Land at Bird in Eye Farm
South of Bird in Eye Hill
Uckfield

PROOF OF EVIDENCE

Re: TRANSPORT MATTERS

Road Safety Audit Report

CLIENT	Croudace Homes Ltd.	DATE	09/02/22
PROJECT	Bird in Eye, Uckfield	DESIGN BY	-
TITLE	Swept Path Analysis Refuse Vehicle Right Turn Lane	DRAWN BY	ARM
		CHECKED BY	MT
DRAWING No.	5330 / 227	SCALE	1:500 @ A3
		REV No.	F

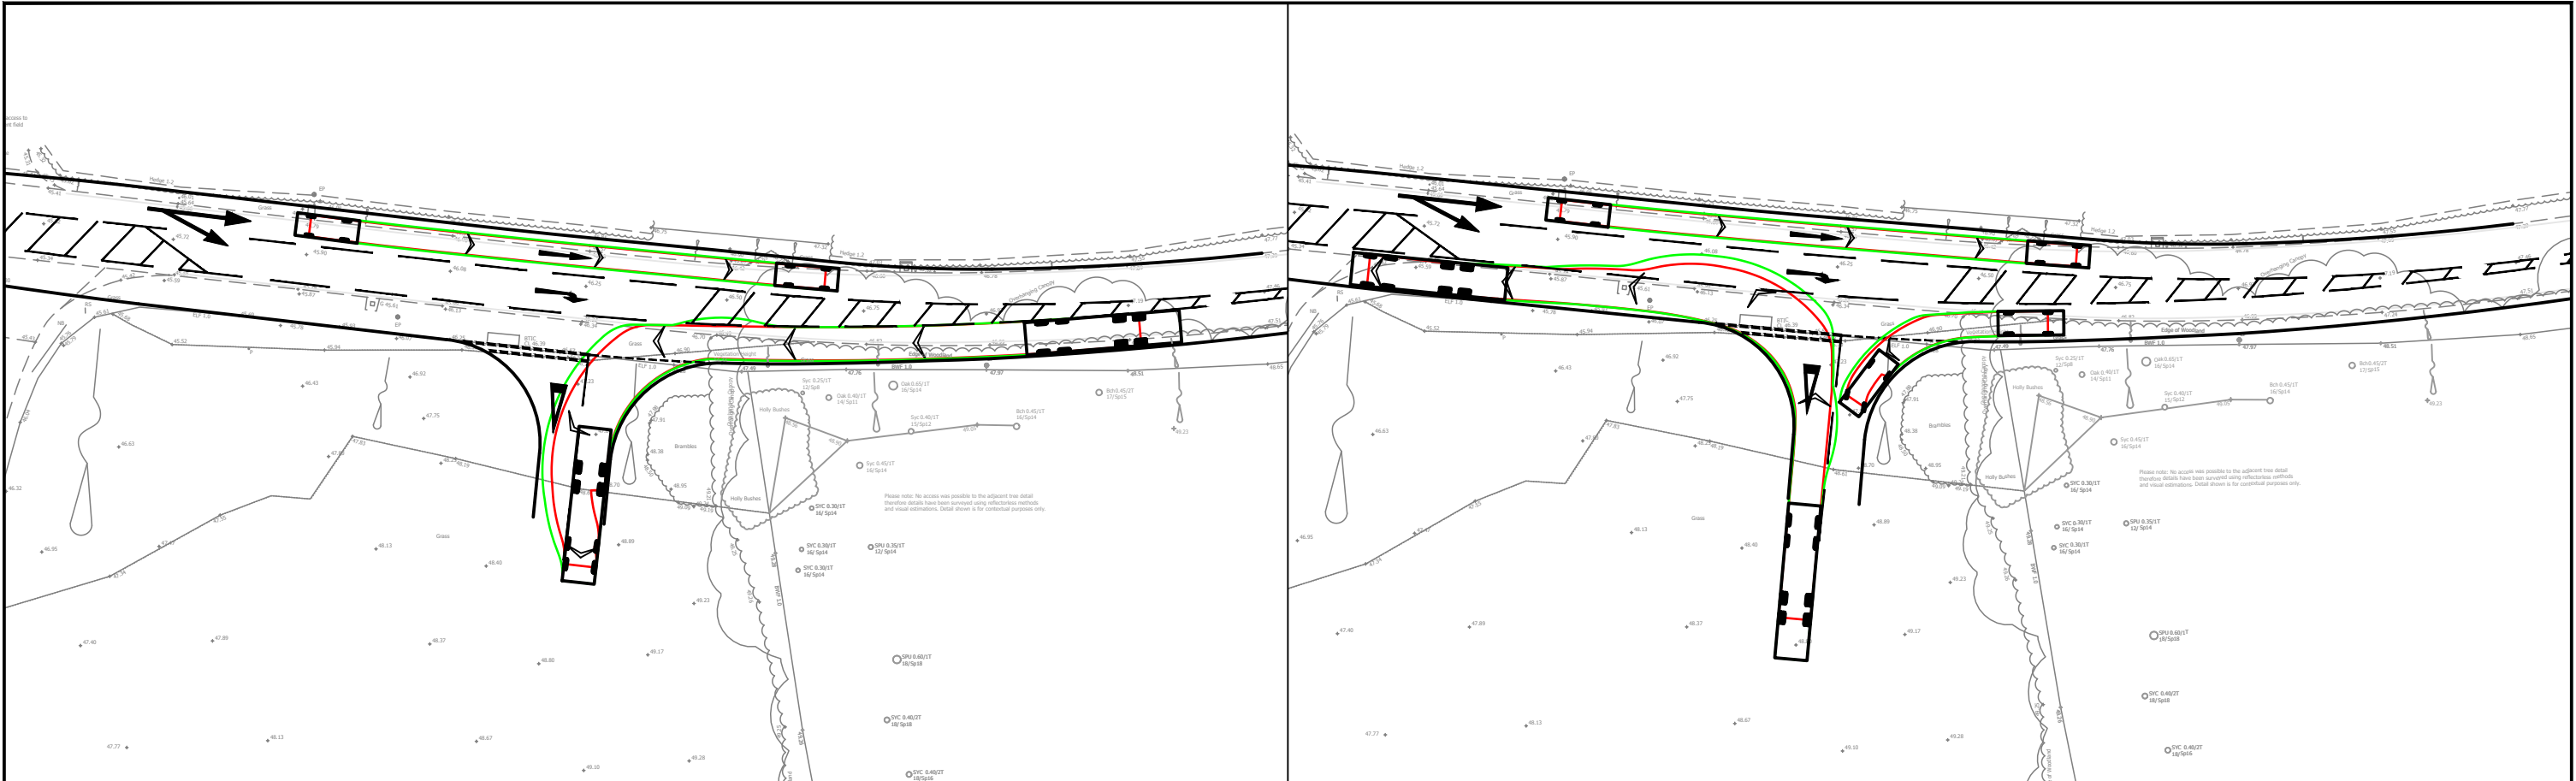
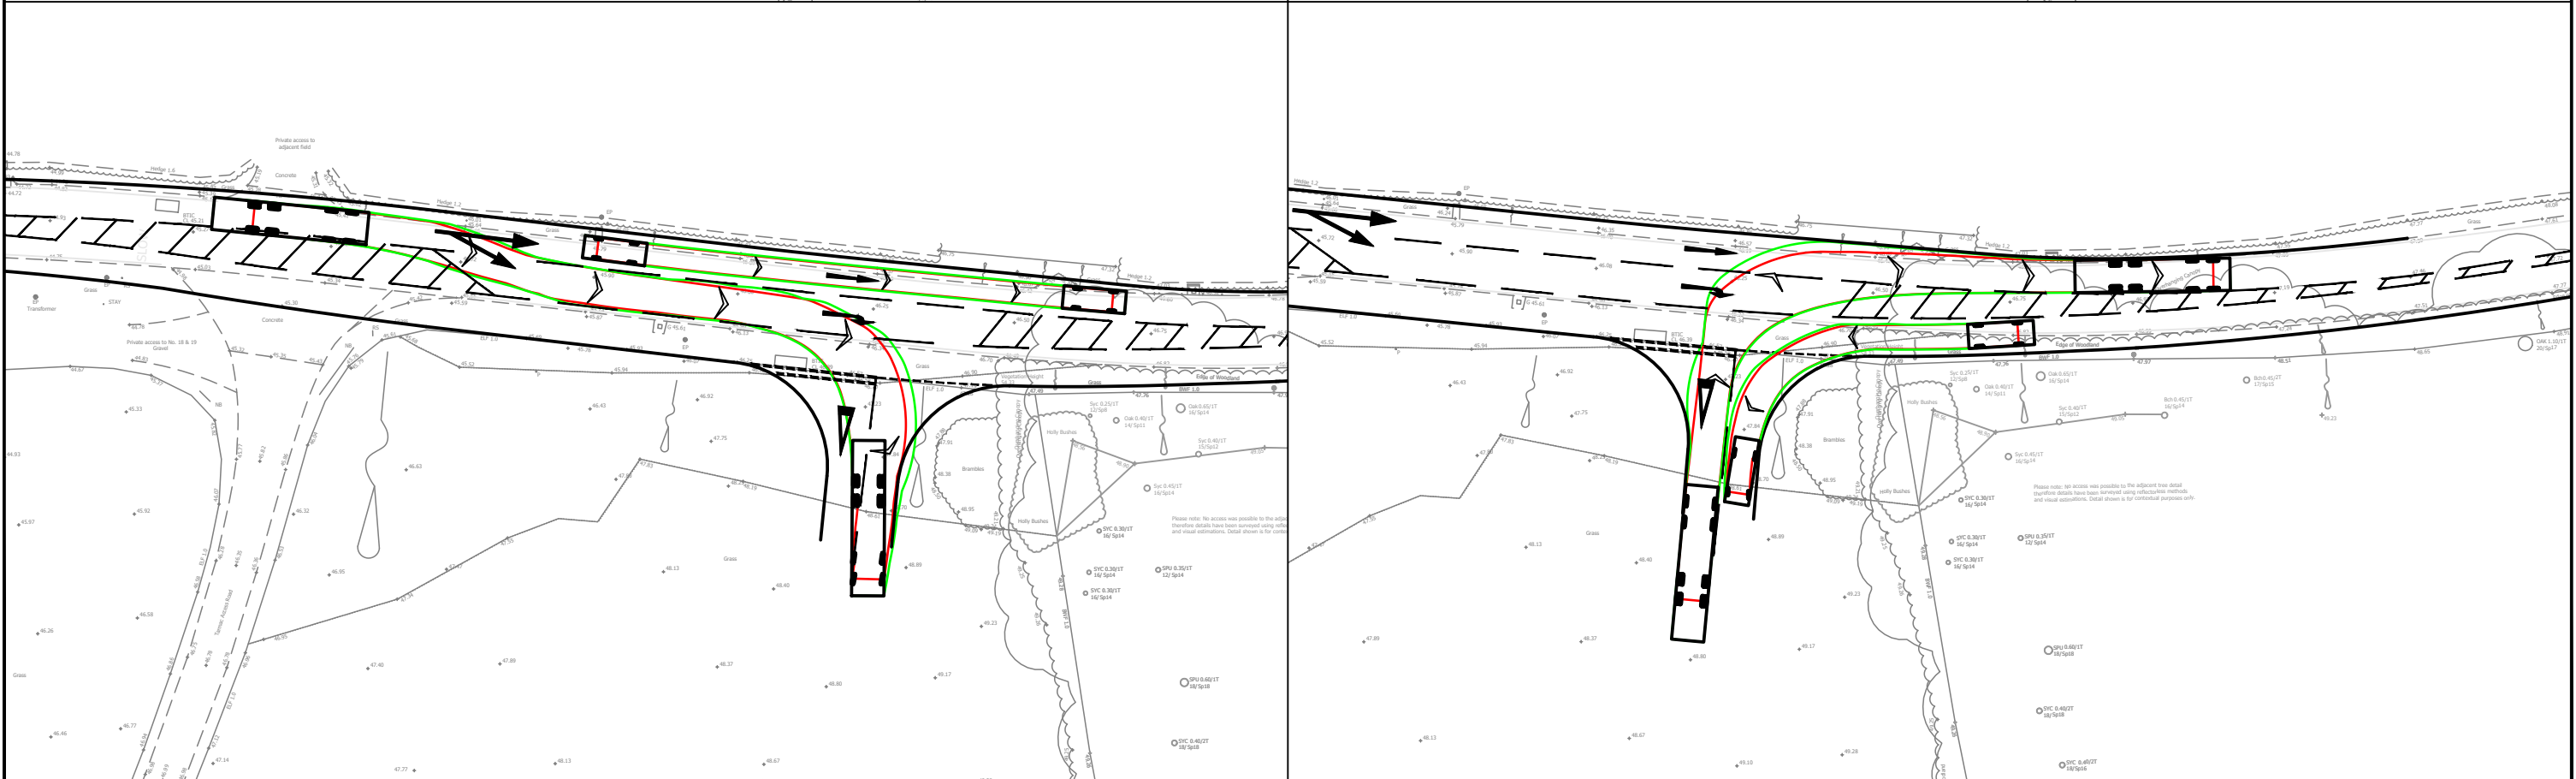
- Tracking drawings - including 227 rev F, 228 rev F - these show overrunning into opposing lanes and do not provide comfort that the junction as shown in Rev M can operate safely. Your reliance on MfS1 6.8.1 is not accepted as being relevant or complete.

Your swept path plans which accompanied the revised design, illustrated on drawings 5330-227 revision F, 5330-228 revision F and 5330-244 revision B indicate that all HGV's apart from 16.5 metre Articulated HGV's, can approach the give-way line when exiting without encroaching the opposing lane. This as well as the survey which identifies that just four two-way HGV movements will be observed at the access throughout a day, addresses item A.3.1 of our Audit, ref: RSA-23-083.

CLIENT					Croudance Homes Ltd.									
PROJECT					Bird in Eye, Uckfield									
TITLE					Proposed Access - Right Turn Lane									
DRAWN BY		ARM			DESIGN BY		ARM		CHK BY		MT			
DATE		02/02/22			DRAWING No.		5330 / 021				REV No.		P	
SCALE		1:500 @ A1

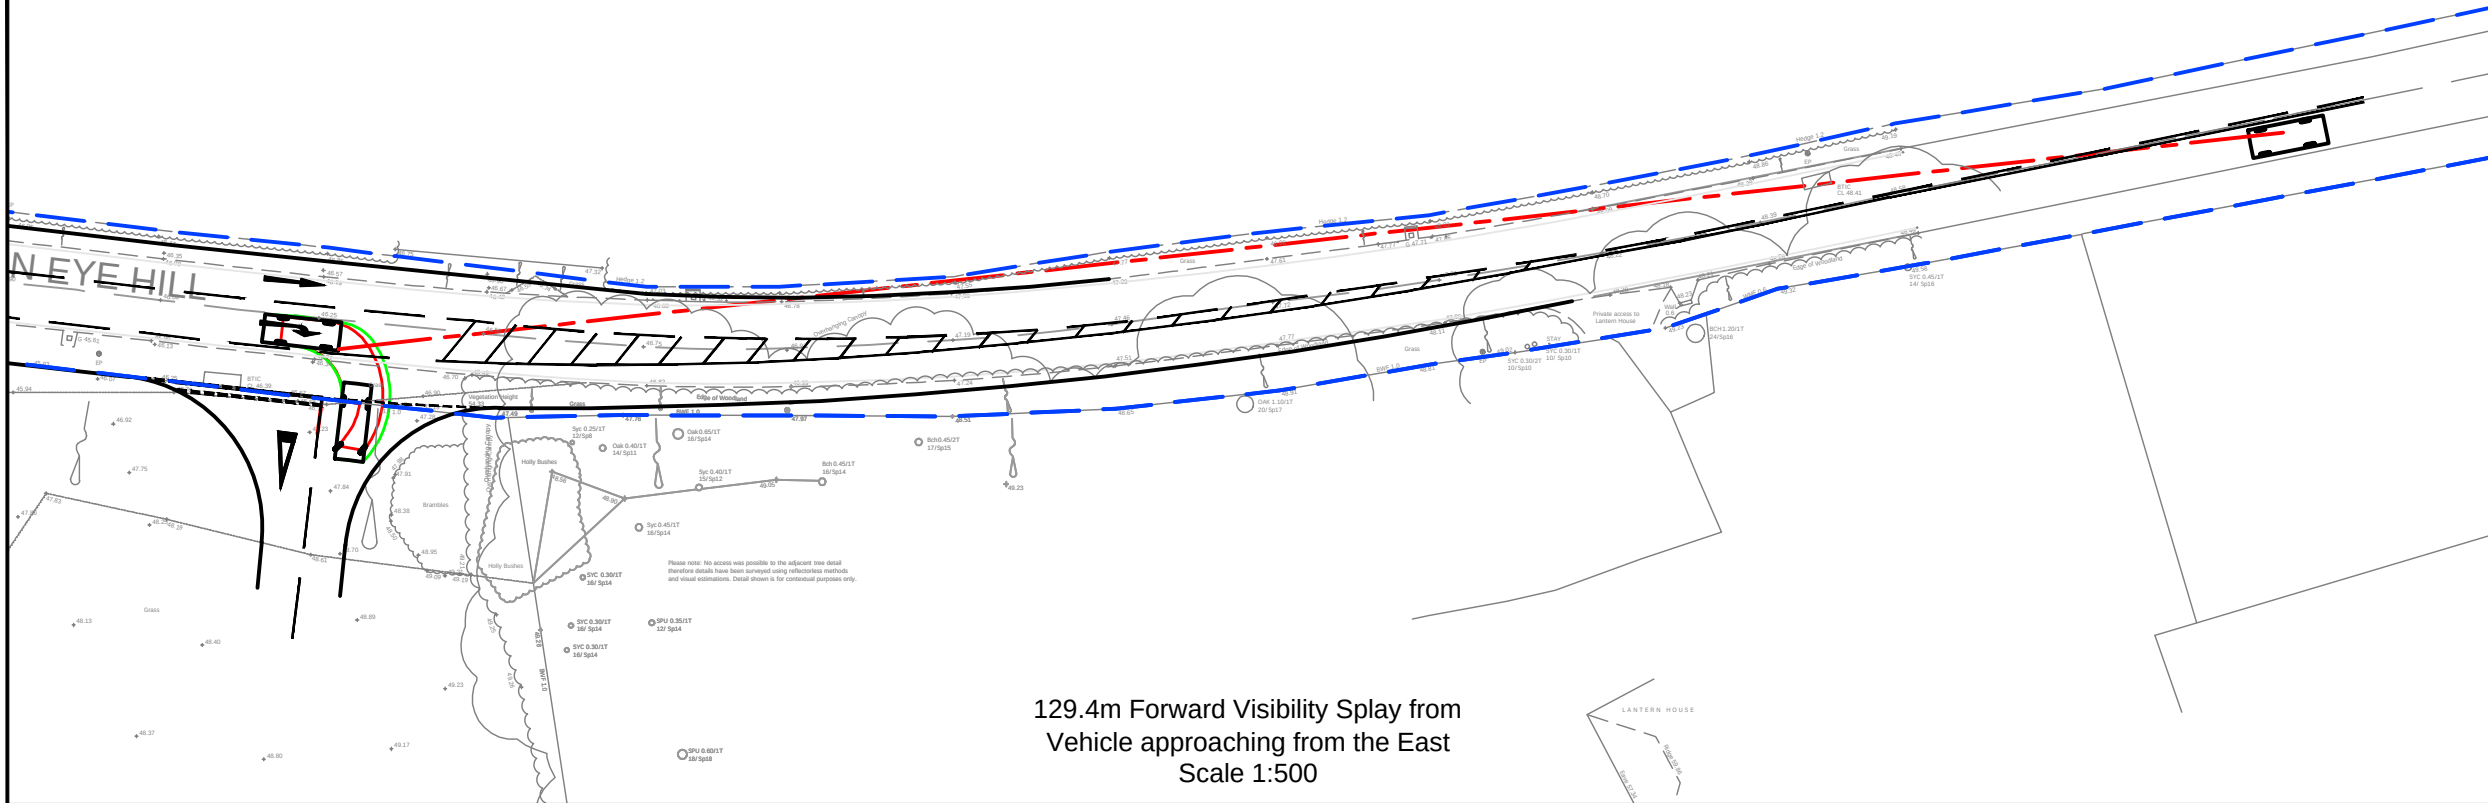
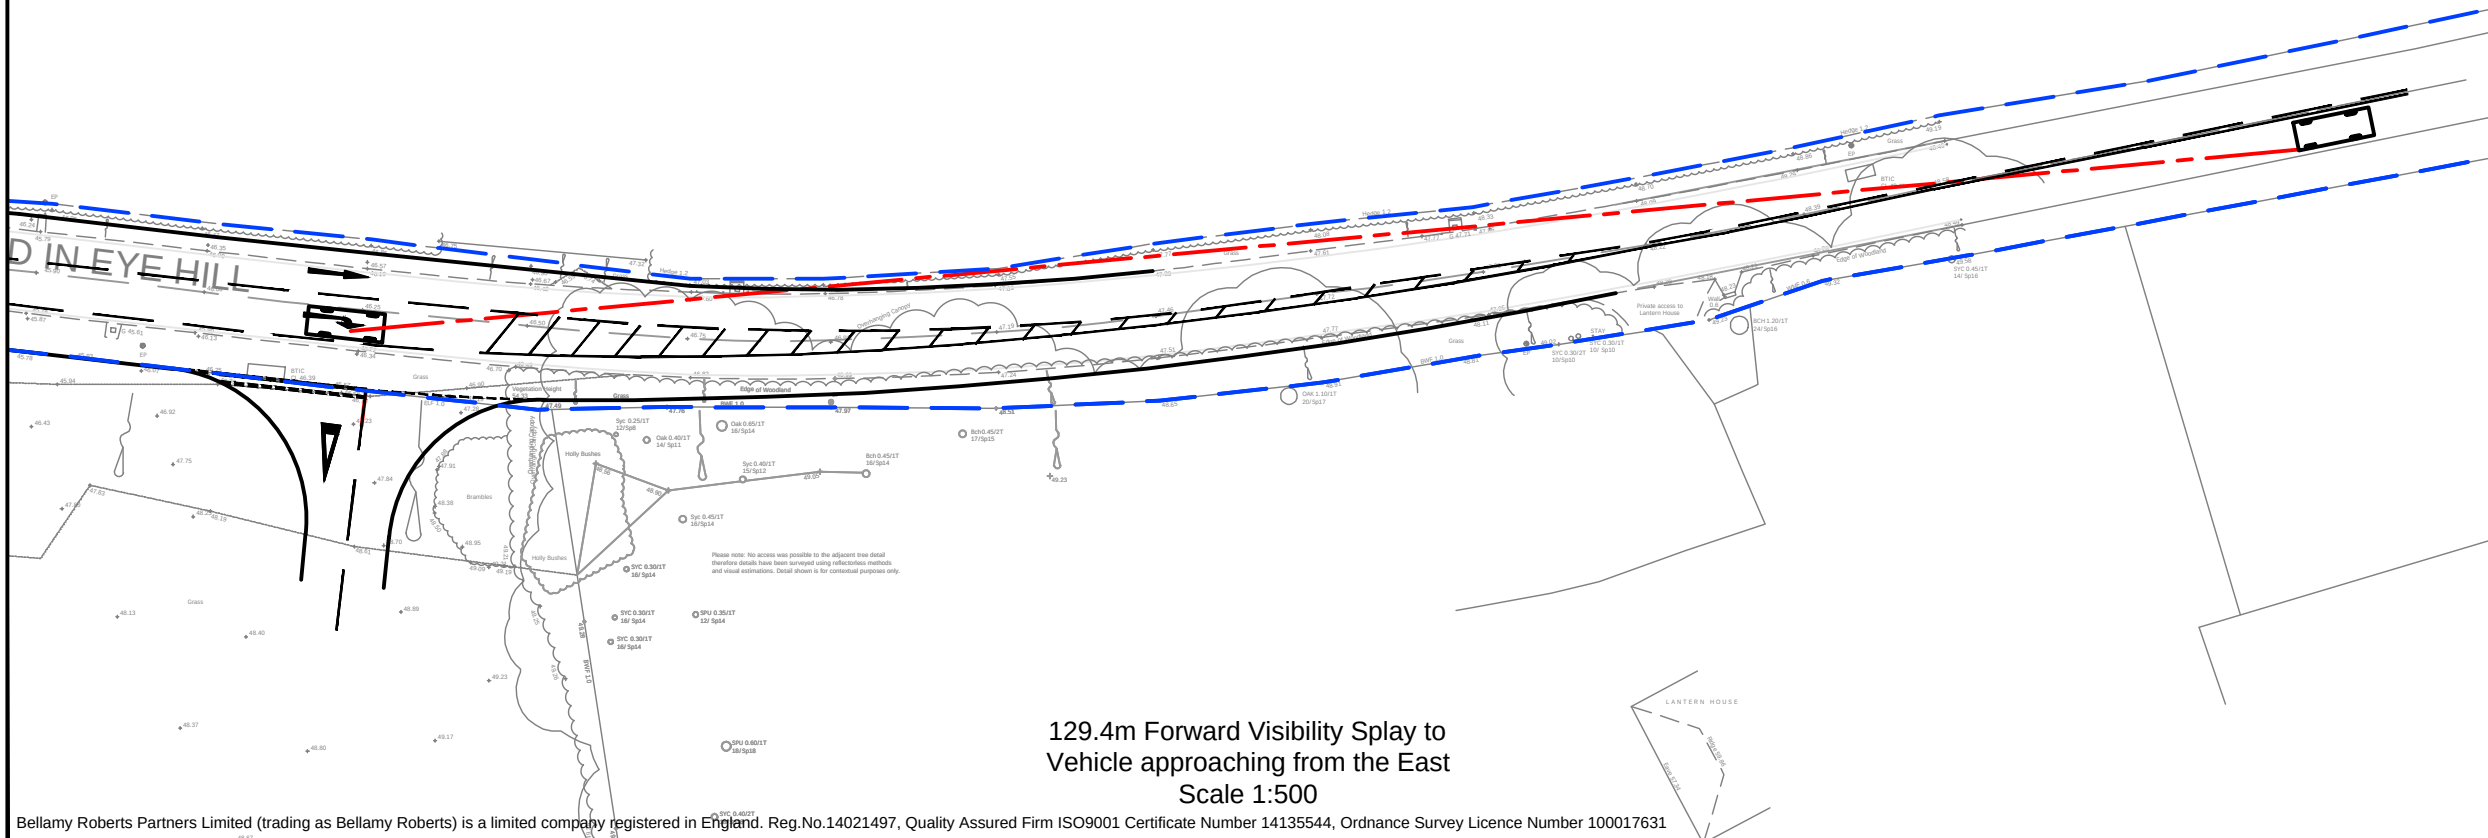
P	Centreline updated. Side road ahead location added.	DC	MT
N	Northern kerbline amended to be a minimum of 450mm from Highway boundary	MB	MT
M	Design Revised, running lanes increased to 3m wide	JCB	MT
L	Design Revised	JCB	MT
K	Design Revised	MB	MT
J	Design Revised	MB	MT
H	Design Revised	JCB	MT
G	Taper revised to 1:25 on RTL	JCB	MT
F	AMENDMENT NOTE	JCB	MT
E	AMENDMENT NOTE	JCB	MT
D	AMENDMENT NOTE	JCB	MT
C	AMENDMENT NOTE	ARM	MT
B	AMENDMENT NOTE	ARM	MT
A	AMENDMENT NOTE	ARM	MT
REVISION	AMENDMENT	DRN	CHK

I can confirm that items A.1.1, A.2.2 and A.3.1 of our Stage 1 Road Safety Audit RSA-23-083, have been addressed within your scheme drawing, 5330-021 revision P.
